SUBJECT: NORTH ANNA POWER STATION, UNIT 1 - AMERICAN SOCIETY OF MECHANICAL ENGINEERS BOILER AND PRESSURE VESSEL CODE, SECTION XI RELIEF REQUEST PRT-03 (TAC NO. MC1829)

SAFETY EVALUATION BY THE OFFICE OF NUCLEAR REACTOR REGULATION

RELIEF REQUEST PRT-03

NORTH ANNA POWER STATION, UNIT 1

Figure 1 Cross-sectional view of head-to-flange weld showing the required inspection volume (within dashed lines) and UT beam. The figure illustrates that inspection from the flange side is severely limited due to transition angle and location of weld.

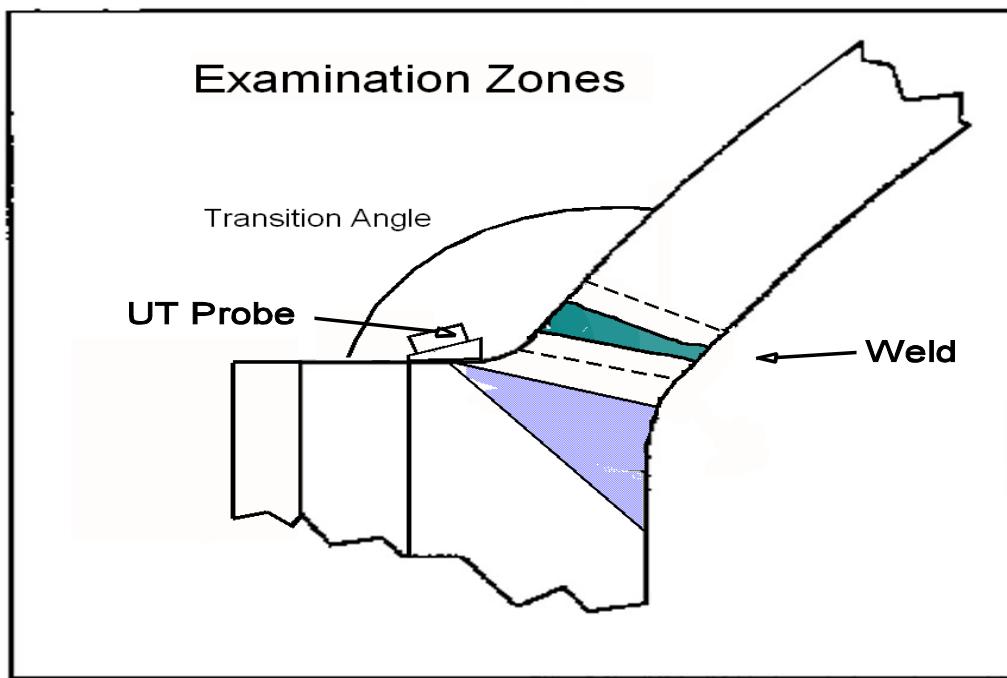
The cross-sectional geometry of the RPV head-to-flange weld produces a high transition angle between the flange and the domed head. As illustrated in Figure 1, scanning from the flange side of the weld is severely limited due to location of the weld and the transition angle. In addition, the location of three closure head lifting lugs further restricts access for performing ultrasonic examination of this weld. For these reasons, the component configuration does not allow the licensee to obtain the full ASME Code-required volumetric coverage from both sides of the weld. For the licensee to achieve 100-percent volumetric coverage, the RPV closure head would have to be redesigned and modified. This would place a significant burden on the licensee, thus the ASME Code-required 100-percent volumetric examination is impractical for the RPV head-to-flange weld.

By letter dated January 22, 2004, the licensee provided information showing that a substantial amount (approximately 66 percent) of the ASME Code-required examination volume can be obtained with the perpendicular, parallel, and 0-degree angle ultrasonic scans that were

performed from the RPV head side of the weld. For both the 45- and 60-degree angle scans, the licensee was able to achieve the ASME Code-required coverage from a single side. In addition to the volumetric examinations of this weld, the licensee was able to obtain essentially 100 percent of the ASME Code-required surface examinations performed on the outside of the component. The examinations completed by the licensee establish a reasonable basis for comparison with future inservice examinations and should have detected any significant conditions that might challenge the structural integrity of the subject welds. Therefore, the licensee's proposed alternative provides reasonable assurance of structural integrity of the subject component.

The NRC staff concludes that for Relief Request PRT-03, the required Code examination coverage is impractical to perform on the subject RPV head-to-flange weld. Furthermore, the NRC staff concludes that the coverage obtained from ultrasonic and surface examinations provides reasonable assurance of structural integrity of the subject component. Therefore, Relief Request PRT-03 is granted pursuant to 10 CFR 50.55a(g)(6)(i) for the third 10-year ISI interval for NAPS-1. The NRC staff notes that this approval is only applicable to preservice examination requirements.
